Subject: **Revised Final Submission - Plan Corrections Narrative**

Re: **DRB23-0974 - E 441 Rivo Alto Drive (currently grouped with 445 Rivo Alto Drive)**

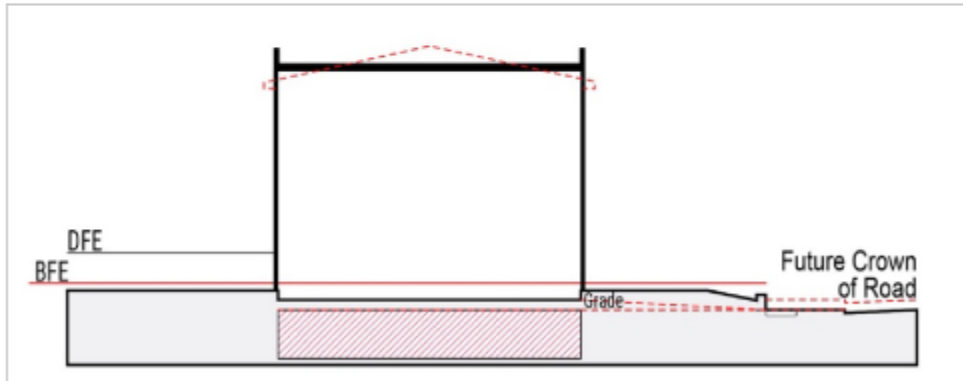
We note that per chapter 7.1.2.2.a of the code, the understory elevation cannot be less than the future crown of road. Per our previous conversations, it was established that for 441 E. Rivo Alto, it was likely that the future crown of road would be 6'-0", and the final elevation determination would be made by the City at a later date. An understory elevation a little higher than 6'-0" with a base flood elevation of 10'-0" as established by our survey would give us enough clearance to plan for parking and a stair up to the habitable first floor.

However, we have also noted that per chapter 7.1.2.3.b of the code, there are minimum and maximum yard elevation requirements. These elevations are set to the Future Adjusted Grade. Per our calculations, our Future Adjusted Grade for the site is 8'-6", or just a few inches shy of 2'-6" higher than our minimum allowable understory elevation. It is also our understanding that the understory floor elevation needs to be higher or equal to adjacent grade for a minimum of two entire sides of the understory, which would make setting an understory less than 8'-6" on our narrow lot challenging.

Additionally, we are confused as setting the understory to 8'-6" with the 10'-0" base flood elevation will only give us 6'-6" of clearance making the understory itself inaccessible. When an understory is used, are yard elevations controlled instead by the understory height itself, and the Future Adjustable Grade calculation is not applicable?

We do not require minimum yard elevations for understory homes. The yards may be lower than the understory elevation.

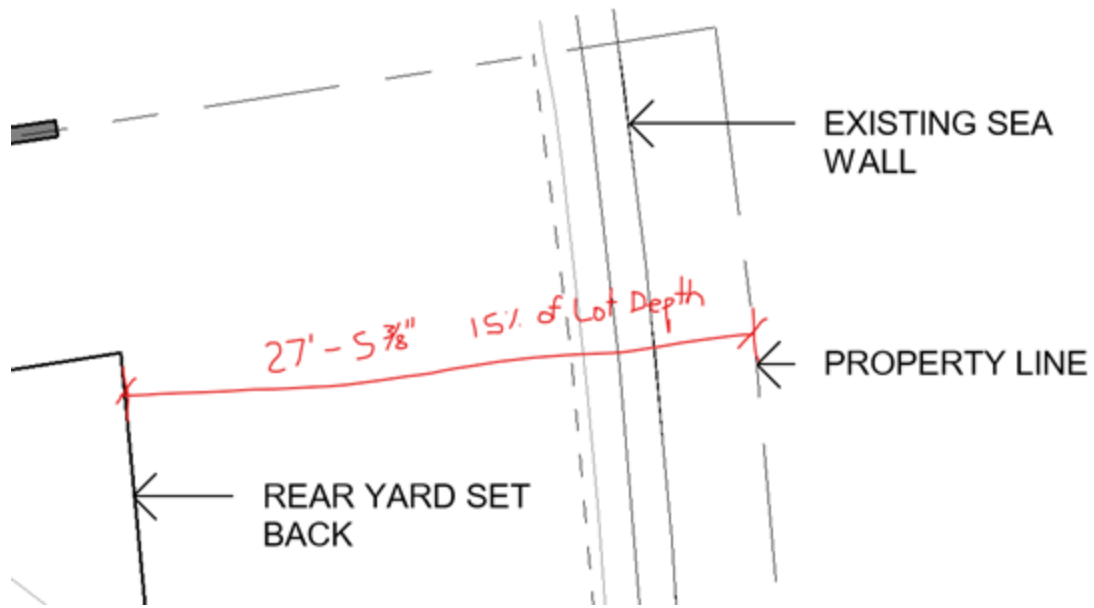
You have spoken to my colleagues Vanessa and Dan in the past about a single-family residence in Miami Beach. I have a quick question for you in regard to the required yard open space calculation from sections 142-105 and 146-106 Code of Ordinances.

- Section 105 requires 70% of the front yard to be sodded or landscaped pervious open space, while section 106 requires only 50%. Are we intended to follow the stricter minimum requirement?
- For the rear yard open space, where should our bayside area measurement stop as our property line is within the bay? See the graphic below. In order to determine if we are meeting the 70% or 50% requirement accurately, should the total available setback area for the pervious open space include the area of seawater that lies within the property line? Or would we only calculate the setback within the existing sea wall?

No portion of submerged land can be used for lot coverage or and setback or lot area calculations. If the property line extends into the water, the lot area is taken at the midpoint of the seawall. Setbacks are also taken from the mid point of the seawall. Understory homes require 70% open space in front, other homes are 50%.
